GREATER NEW HAVEN WATER POLLUTION CONTROL AUTHORITY

IMPROVING FATS OIL AND GREASE RECEIVINGS

Project SSF 2020-03

ADDENDUM #3

DRAWING NUMBER
M-80-102

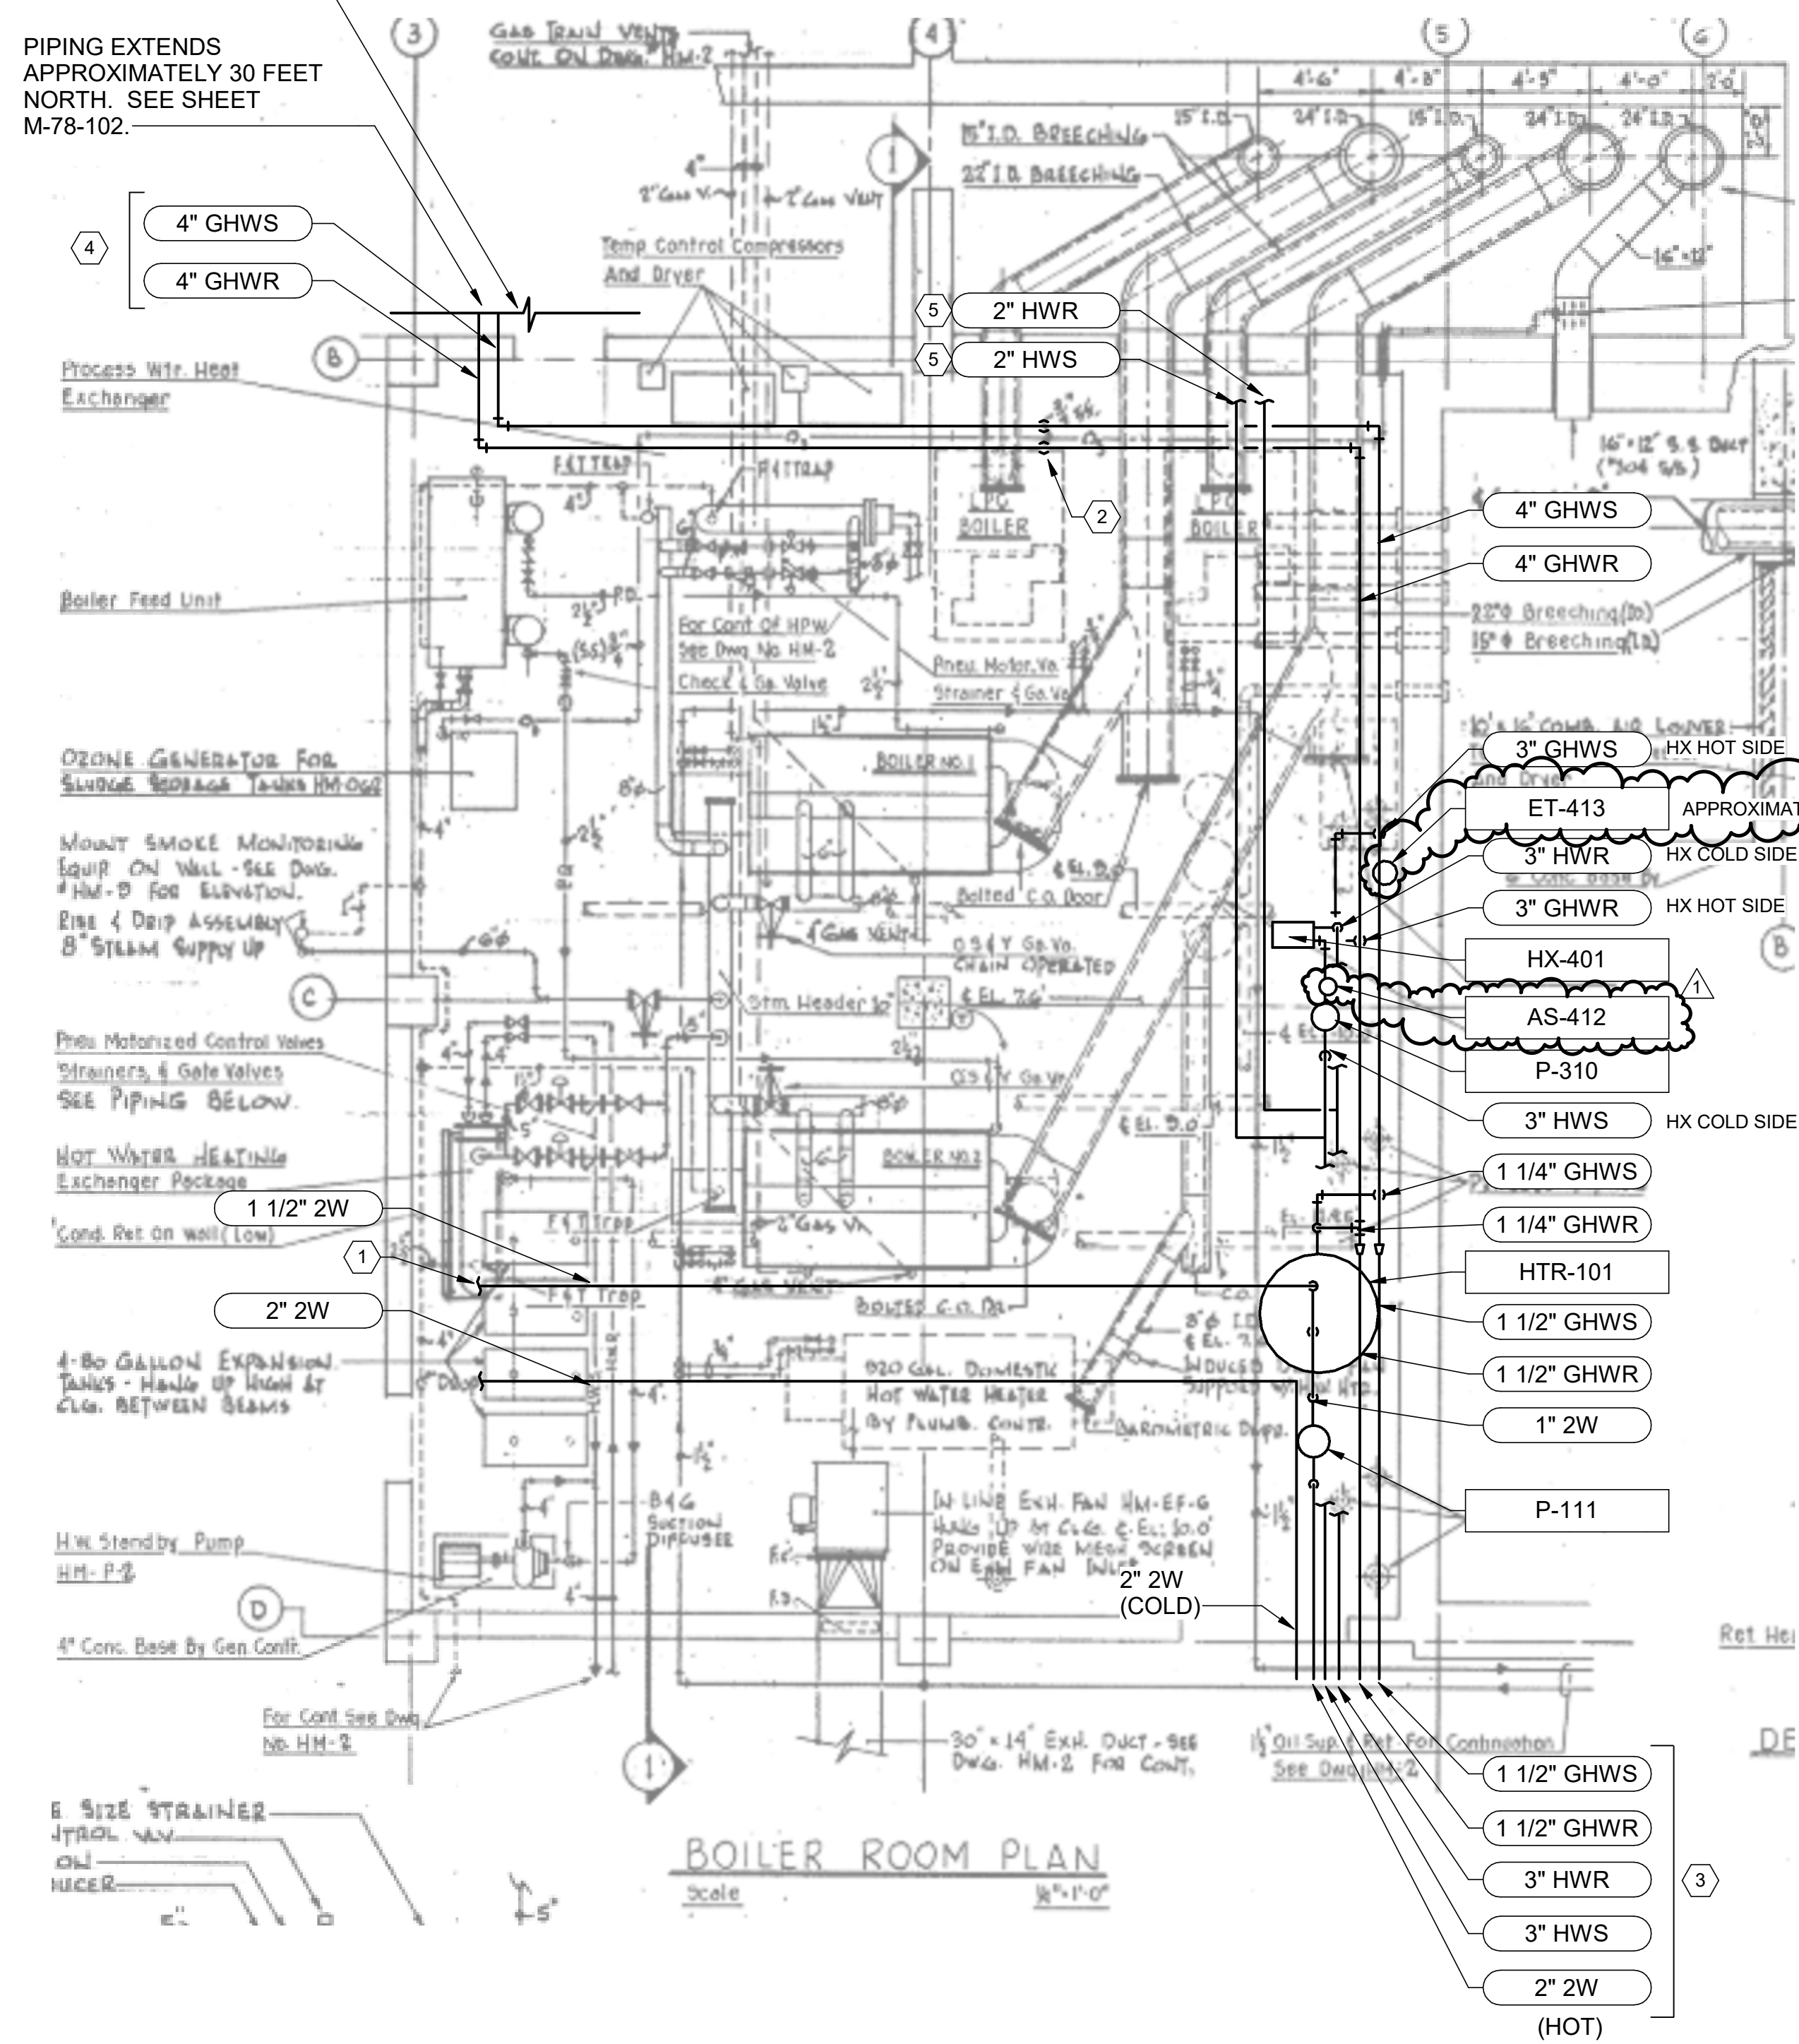
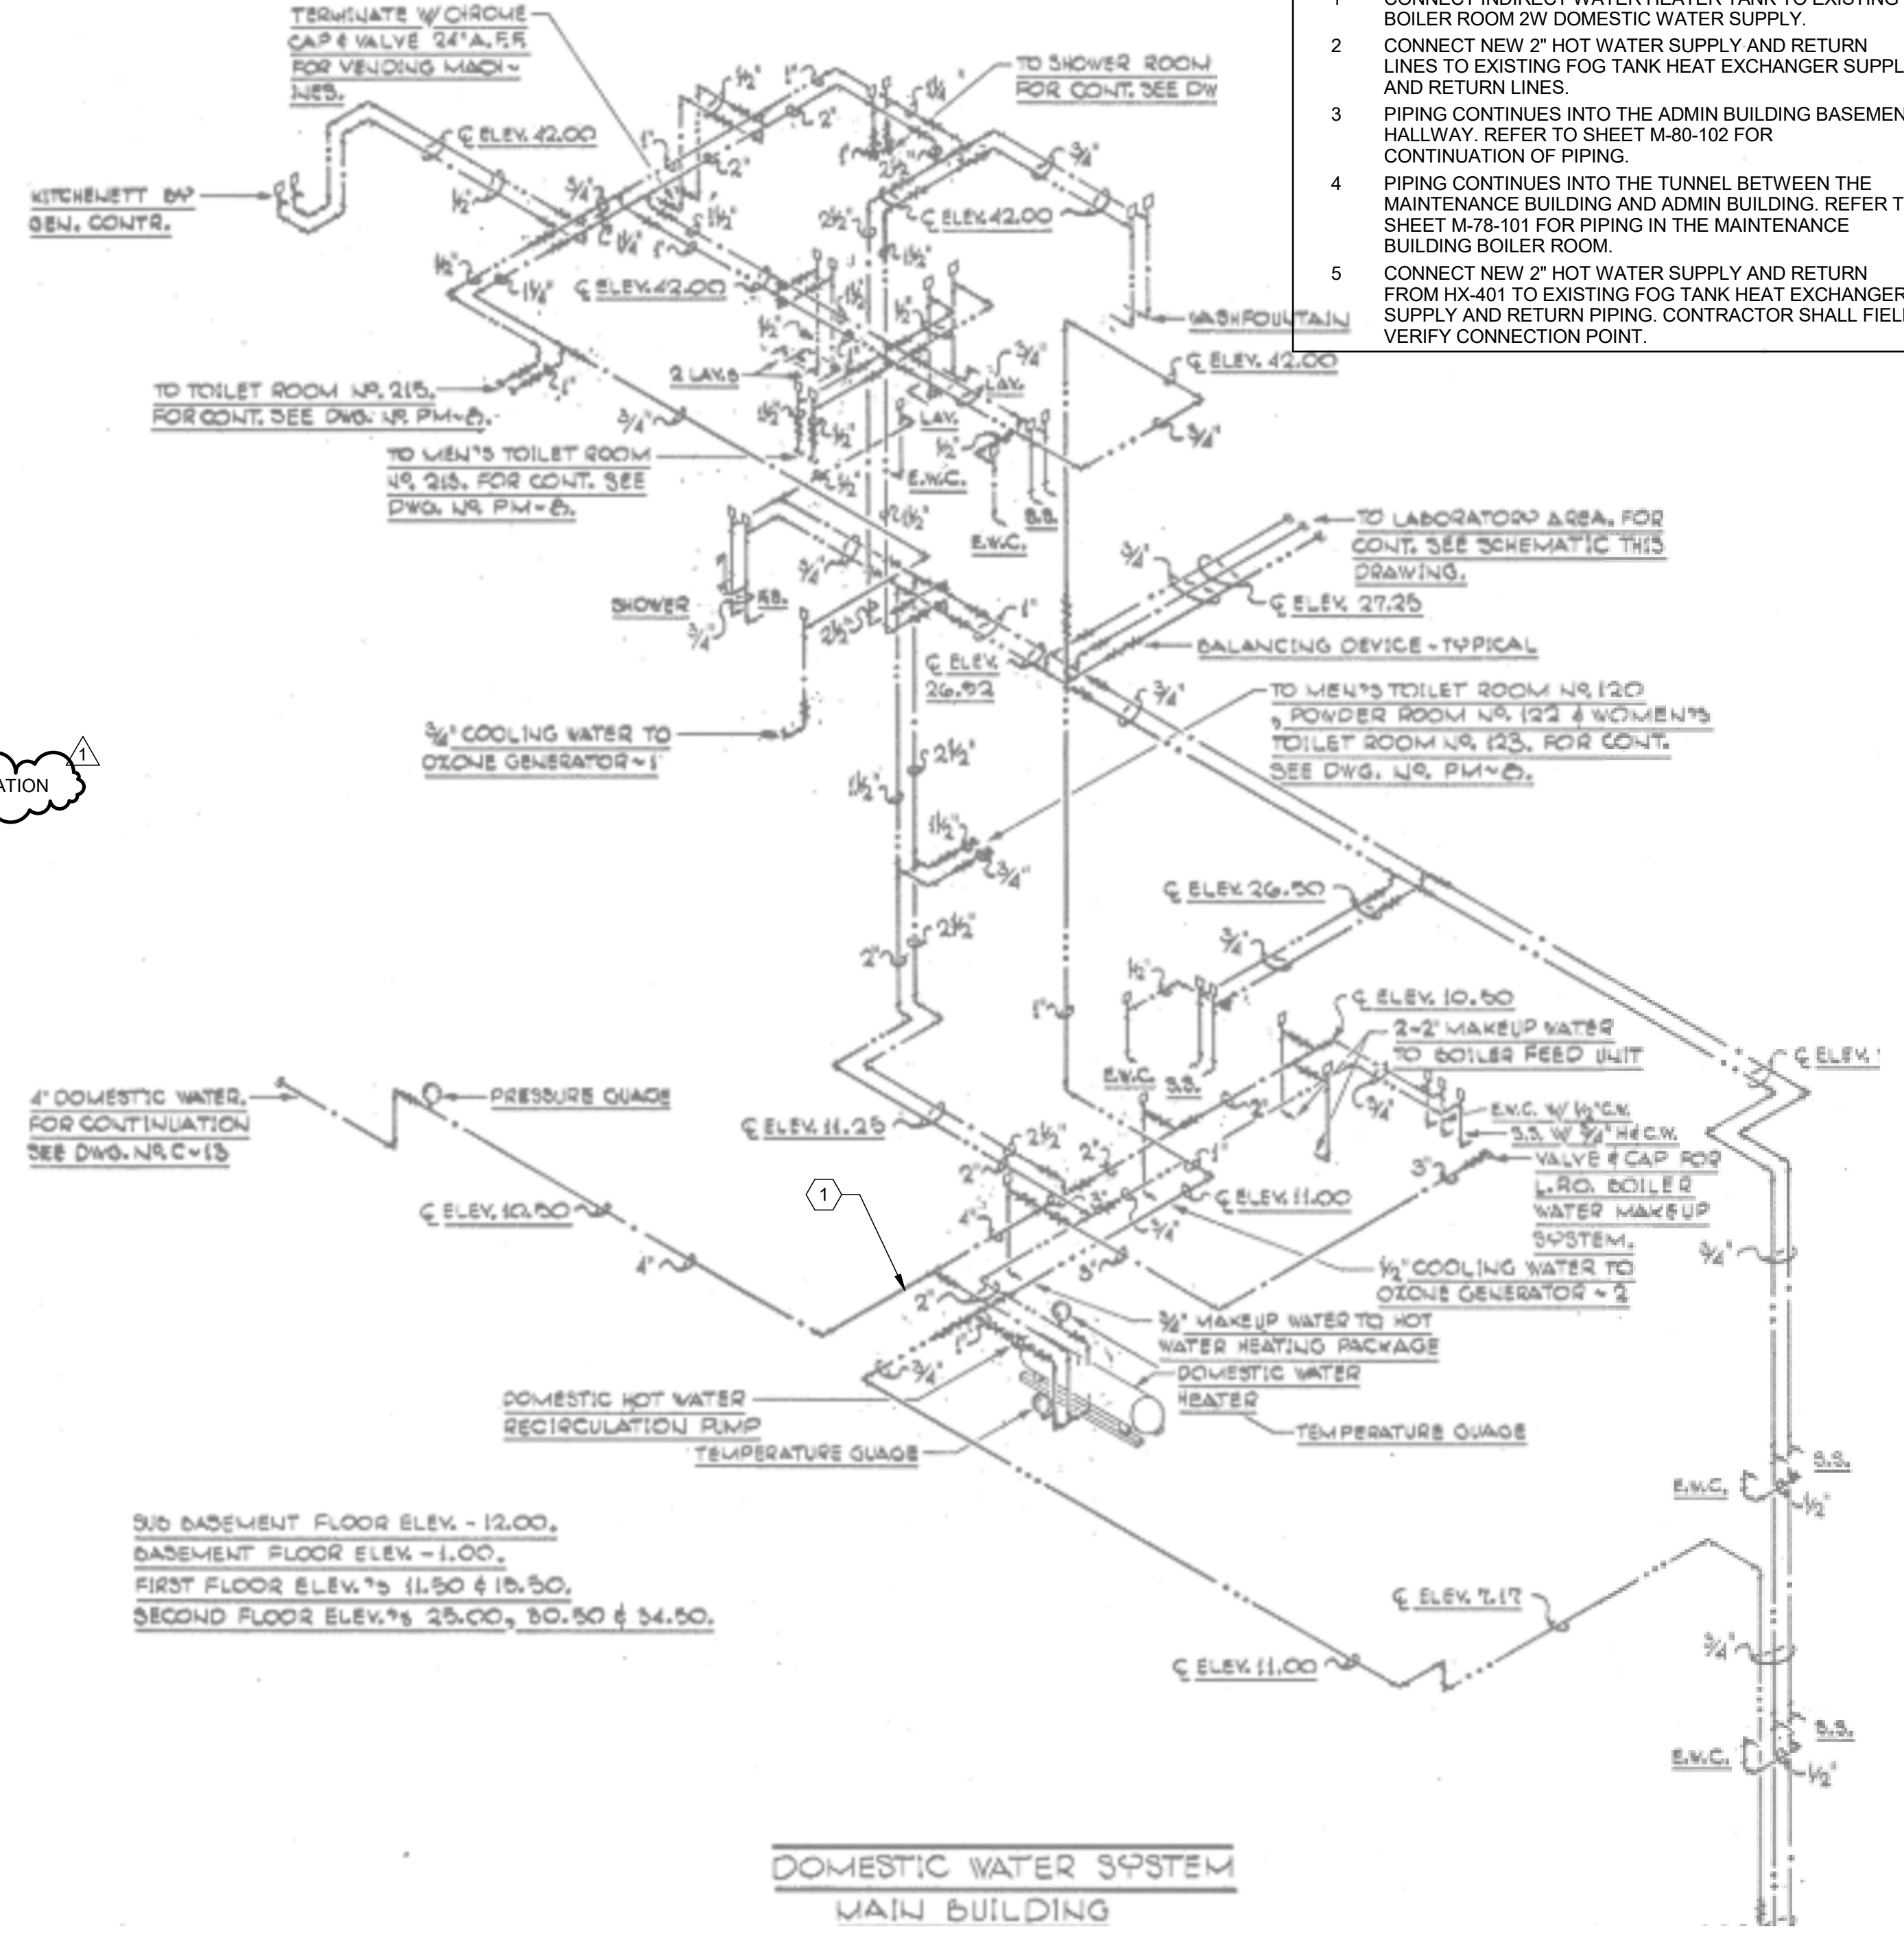
1. **Question:** Drawing M-00-602 - Regarding the closed loop served by pump P-310 on the on the FOG Tank side of HX-401. Should there be an air separator, expansion tank, auto feeder & backflow preventer on the closed loop?
- i. **Response:** Yes, refer to updated drawings M-00-601, M-00-602, M-78-101, and M-80-102.
